Access Compliance Report

Public Rights-of-Way

(Curb Ramps)

Intersection ID: 23715	Main Street: BRANDON_FOREST_DR	Cross Street: VON_THURINGER_CT	Location: SW
ADA ID: F3575C47AA22	Ramp Type: PerpDiag	Initial Pass/Fail: Fail	Overall Compliance: No
Severity Score: 33.75			
Codes/Mitigation Info/Possible Solution		Field Measurements/Component Compliance

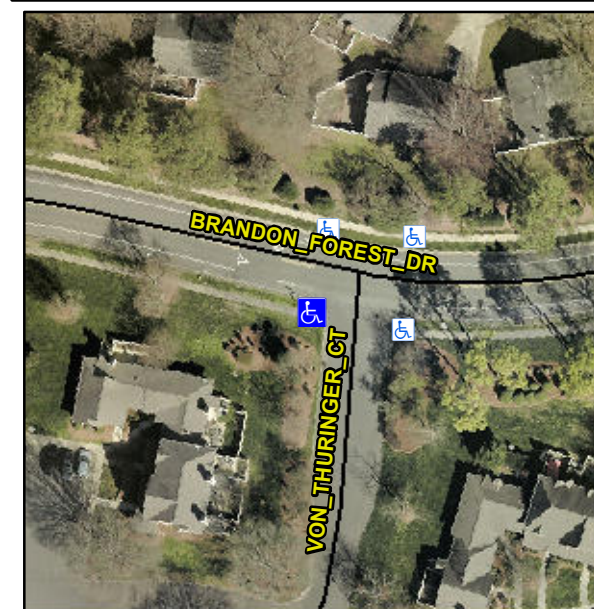
Not Found, R304.5.1, R304.5.3

Compliance	Description	Data	Compliance	Description	Data
N/A	Ramp Length (in)	52.0	Yes	Ramp Slope (%)	7.4
No	Ramp Width (in)	38.0	No	Ramp XSlope (%)	8.6
N/A	Flare Type LT	N/A	N/A	Flare Type RT	N/A
N/A	Flare Slope LT (%)	N/A	N/A	Flare Slope RT (%)	N/A
N/A	Flare Traversable LT?	N/A	N/A	Flare Traversable RT?	N/A
N/A	Landing Length (in)	N/A	N/A	DWS Provided?	N/A
N/A	Landing Width (in)	N/A	N/A	DWS Contrast?	N/A
N/A	Landing Slope (%)	N/A	N/A	DWS Length (in)	N/A
N/A	Landing X Slope (%)	N/A	N/A	DWS Full Width?	N/A
N/A	Landing Curb? (Y/N)	N/A	N/A	DWS Offset (in)	N/A
N/A	Shared Landing?	N/A			
N/A	Gutter Ponding?	N/A	N/A	Gutter Slope (%)	N/A
N/A	Gutter Lip Ht (in)	N/A	N/A	Gutter X Slope (%)	N/A
N/A	Painted X Walk1?	No	N/A	Painted X Walk2?	No
	X Walk 1 Direction	To SE		X Walk 2 Direction	To N
N/A	X Walk 1 Width (in)	N/A	N/A	X Walk 2 Width (in)	N/A
	X Walk 1 Slope (%)	0.4		X Walk 2 Slope (%)	4.3
	X Walk 1 X Slope (%)	0.8		X Walk 2 X Slope (%)	1.8

Remove & Replace Curb Ramp With Two New Directional Ramps or Equivalent.
